UNITED STATES
DEPARTMENT OF THE INTERIOR
BUREAU OF LAND MANAGEMENT
SUNDRY NOTICES AND REPORTS ON WELLS

5. Lease Serial No.	NMNM-0121121
6. If Indian, Allottee or Tribe Name	
7. Unit or CA Agreement Name and No	
8. Well Name and No.	Cotton Draw Unit 110
9. API Well No	30-015-36406
10. Field and Pool, or Exploratory	Paduca; Delaware
11. County or Parish State	Eddy NM

TYPE OF SUBMISSION	TYPE OF ACTION			
☒ Notice of Intent	☐ Acidize	☐ Deepen	☐ Production (Start/Resume)	☐ Water Shut-Off
☐ Subsequent Report	☐ Alter Casing	☐ Fracture Treat	☐ Reclamation	☐ Well Integrity
☐ Final Abandonment Notice	☐ Casing Repair	☐ New Construction	☐ Recomplete	☒ Other Rig Layout Change
	☐ Change Plans	☐ Plug and Abandon	☐ Temporarily Abandon	
	☐ Convert to Injection	☐ Plug Back	☐ Water Disposal

13-5/8" 3K Annular

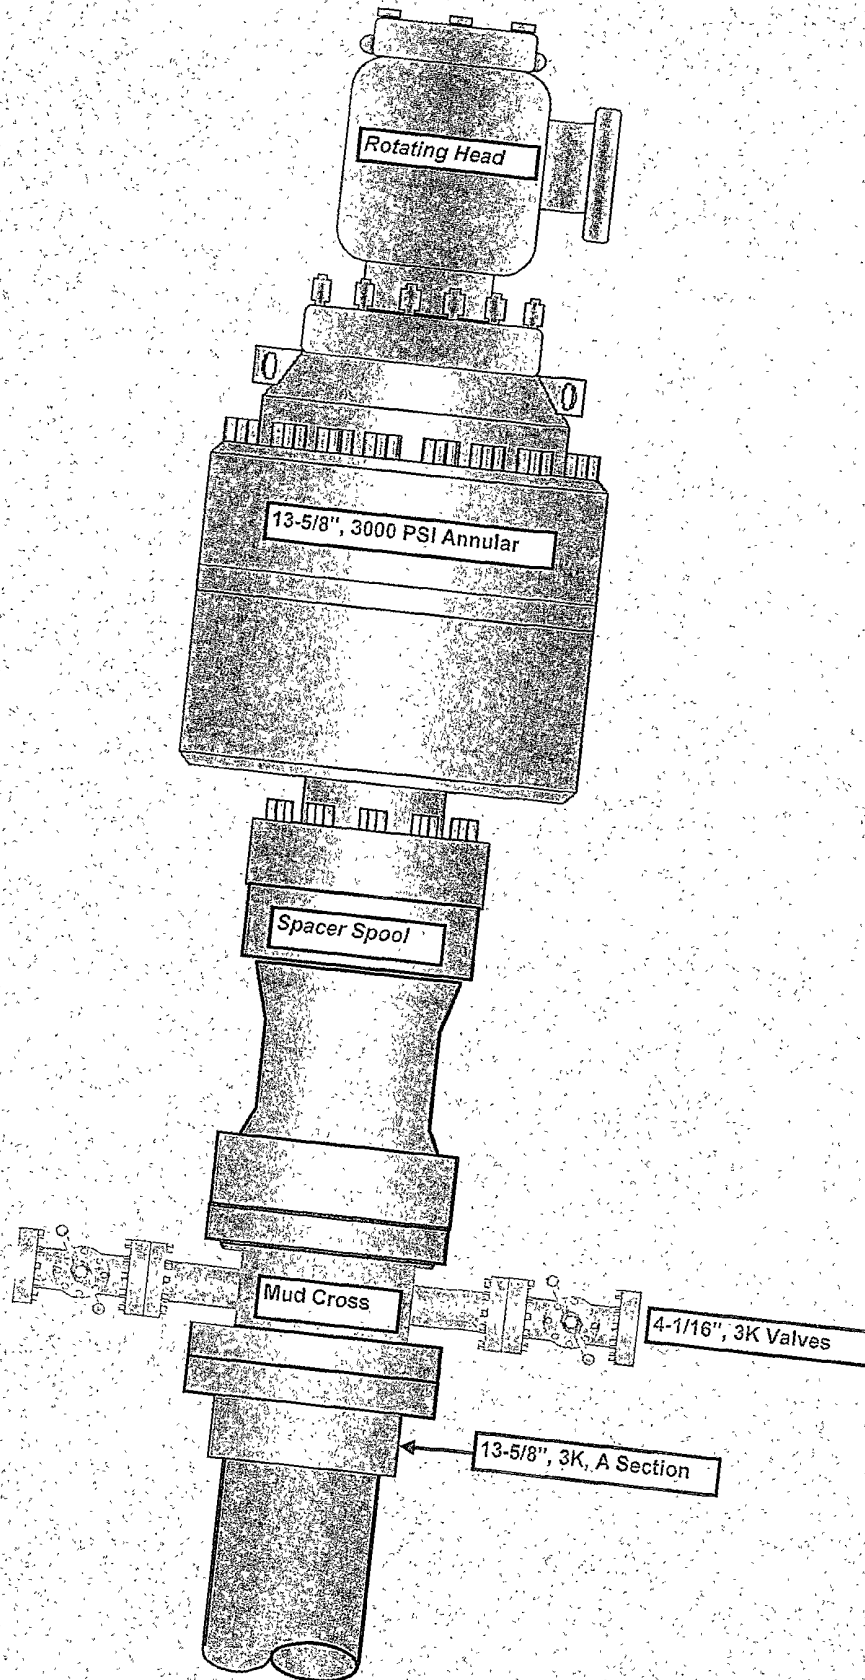
Devon Energy Production Company L. P. respectfully requests permission to change the Rig Layout from Basic Energy Services to Patterson 41. The 13 5/8" 3K Annular nipped up on the surface casing to drill the intermediate hole. Request variance to pressure test with rig pump prior to drilling intermediate hole. The 11" 5K Annular and double rams (pipe & blind) nipped up on the intermediate casing to drill the production hole.

Operator will test
to 70% burst-independent
11/25/09
